917 NE 63rd St

3039964-LU
Northeast Design Review Board
Design Recommendation Meeting
December 4, 2023

Ground Floor Units Design at EDG

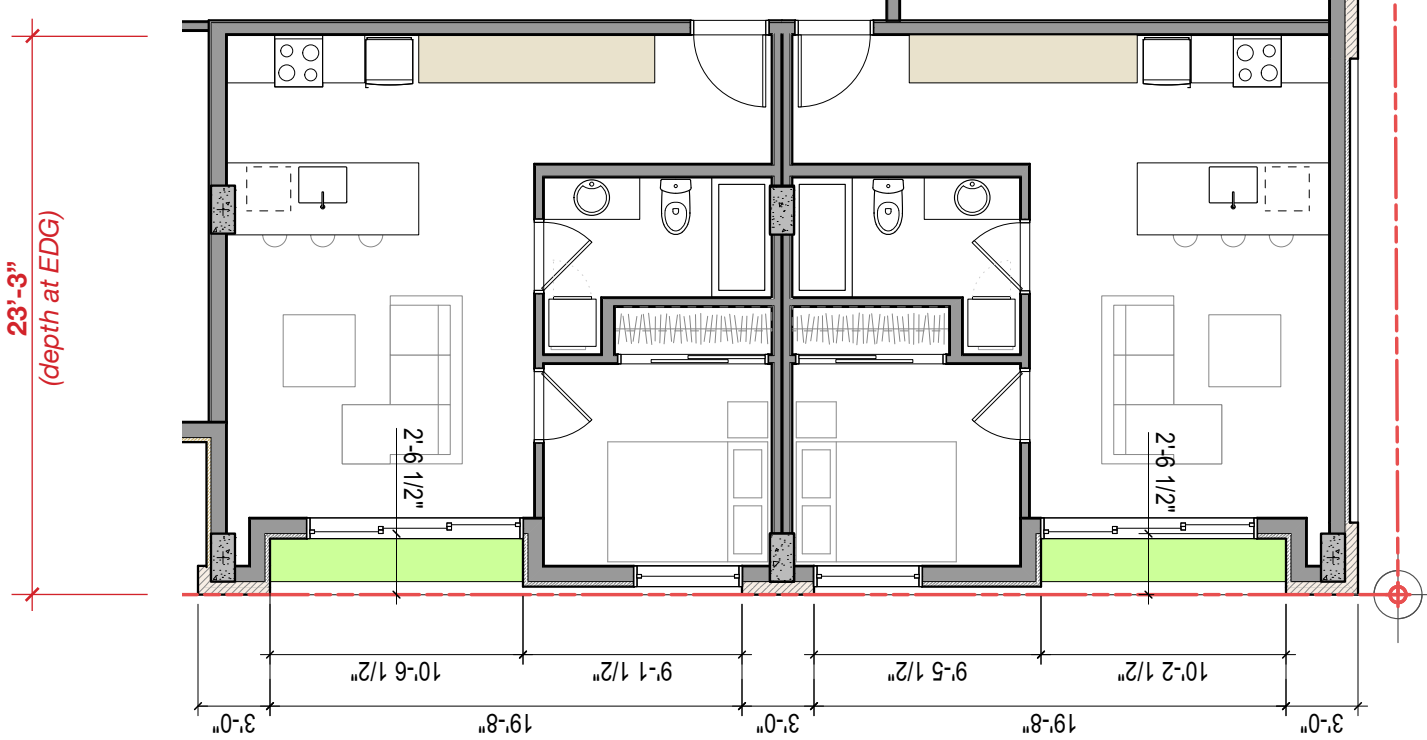
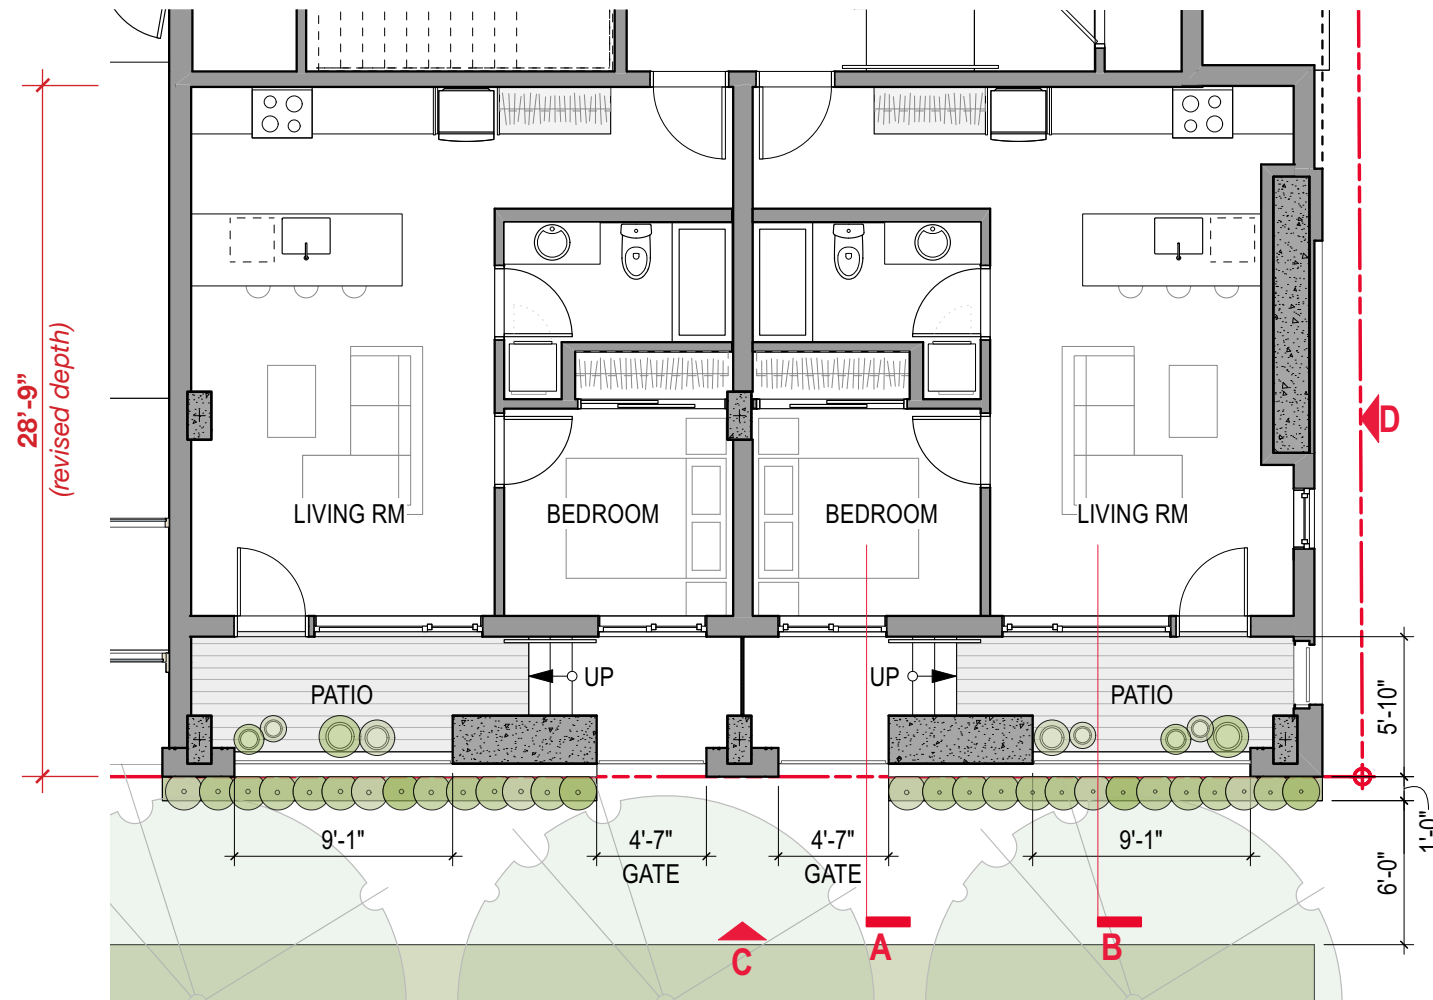
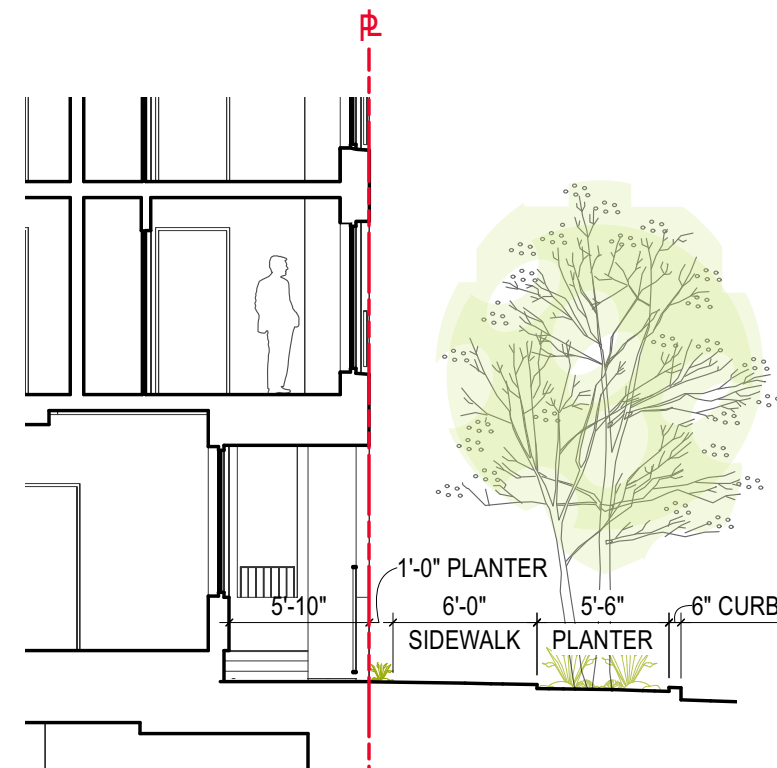
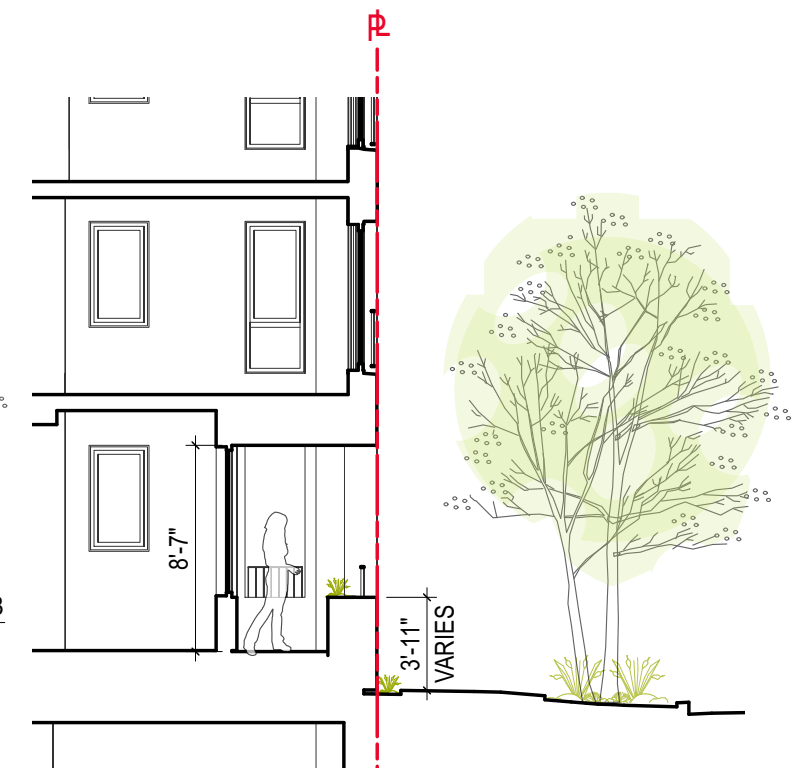
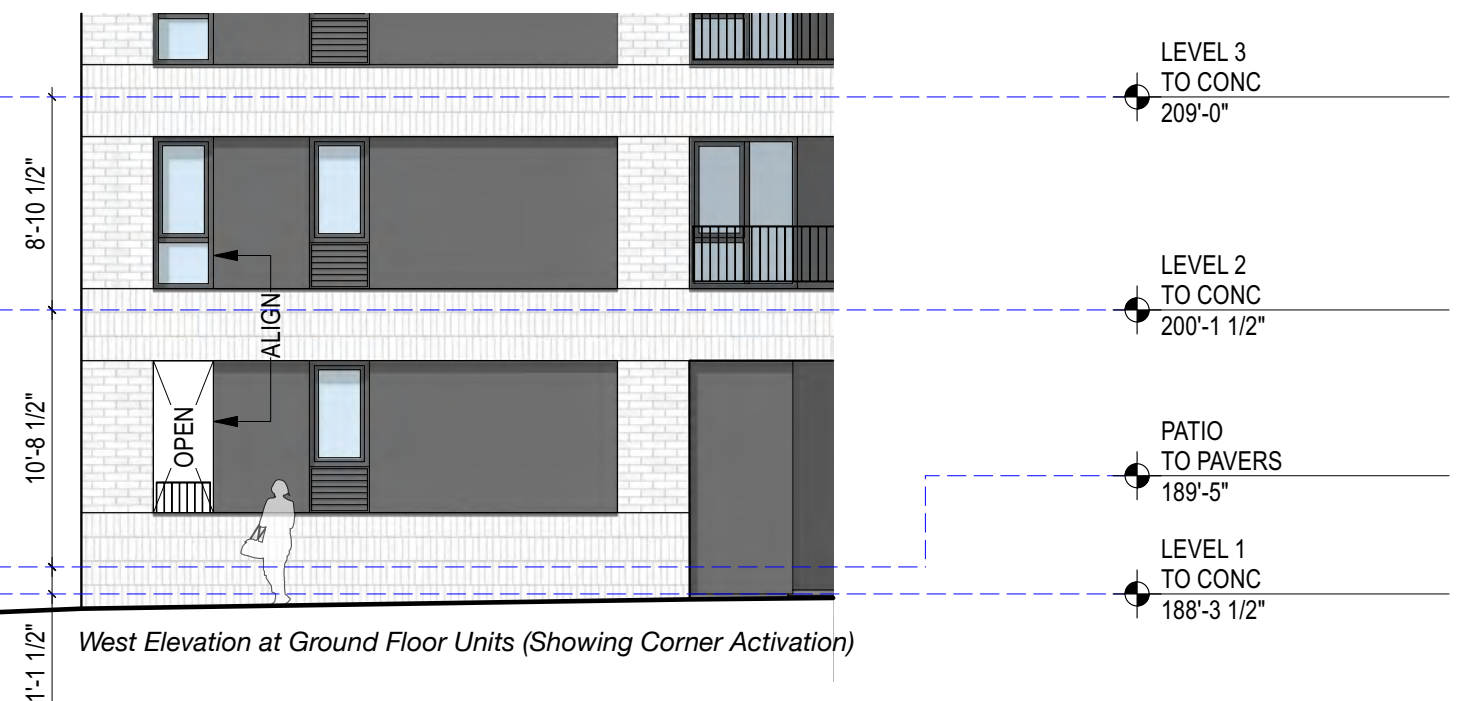
- a. The Board provided guidance to study strategies to *activate the alley and soften the northwest corner* of the development site. (CS2-B-1 Site Characteristics, CS2-D-4 Massing Choices, DC4-D-4 Place Making)
- d. The Board supported the use of a consistent design language and the layering of elements to establish depth and visual interest on the facades of the street-level dwelling units. However, the Board expressed concern about the visibility of the bedrooms from the public right-of-way and *recommended that the applicant reconfigure the ground-level residential units' floor plans* to facilitate transparency without sacrificing residential privacy. (PL4-A Entry Locations and Relationships, Roosevelt Guidance DC2-II Architectural and Façade Composition, DC4-A-1 Exterior Finish Materials)

- The ground floor units have been reconfigured to improve privacy and activation at the alley and NW corner and improve resident and pedestrian experience.
- A stoop has been added as well as outdoor access for the two units and railings to increase privacy and move the exterior wall further away from the right of way (PL4-A Entry Locations and Relationships).
- A 1' planting zone has been added between the sidewalk and the unit.
- As a result of these design developments, these units have greatly increased privacy, while maintaining activation and transparency, than what was previously shown at EDG (DC4-D-4 Place Making).
- The NW corner has windows and high quality brick wrapping the corner as well as the stoop and railings (DC4-A-1 Exterior Finish Materials, Roosevelt Guidance DC2-II Architectural and Façade Composition).

- Overall unit plan has grown 5'-6" to be more generous and further from the sidewalk.
- The bedroom and living room have been pulled off the sidewalk to increase privacy while maintaining street activation.
- A stoop has been added as additional buffer from the sidewalk.
- The sidewalk has been pulled off the building 1' and a planter added to further increase privacy to the residential units and soften the NW corner.
